Technical Bulletin

Subject: Trim Panels, Rattle

Number: 05-02

Model(s): A6

Below VIN: 4F_5N003525:

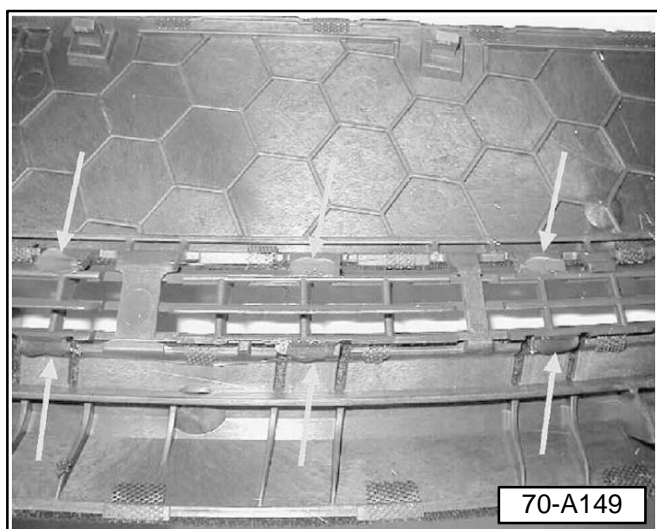
Defrost grill trim has loose holding clips.

Holding clips for defrost trim grill improved after VIN: 4F_5N003525.

- ◀ - Secure all holding clips to defrost grill trim with hot glue (see illustration).
- Verify position of Glove box door.

Below VIN: 4F_5N062705:

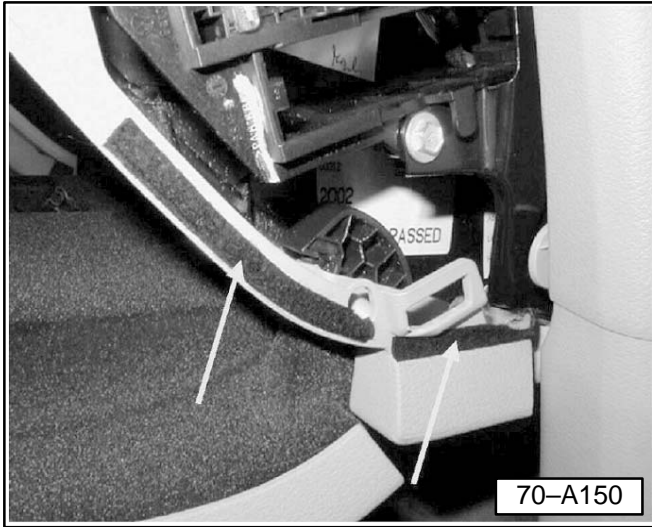
Gap between defrost trim grill and windshield is too small.

Installation of felt strip on right side of defrost trim grill (size 20mm x 20mm x 6mm) after VIN: 4F_5N062705.

- ◀ – Install foam block Part No: 443 201 365B (size 20mm x 20mm x 6mm) to right side of defrost trim grill as shown.

Below VIN: 4F_5N060000:

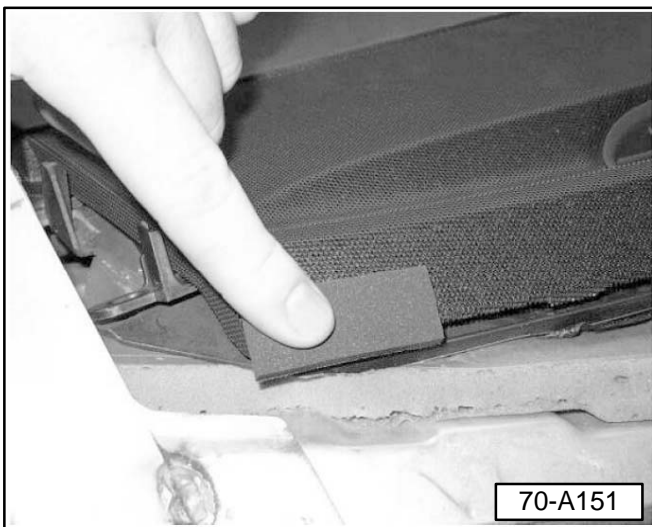
Left and right side cover trim creaking against dash panel.

Side covers for dash panel improved after VIN: 4F_5N060000.

- ◀ – Install two felt strips as shown (see illustration).
- Apply Teflon spray to holding clips.
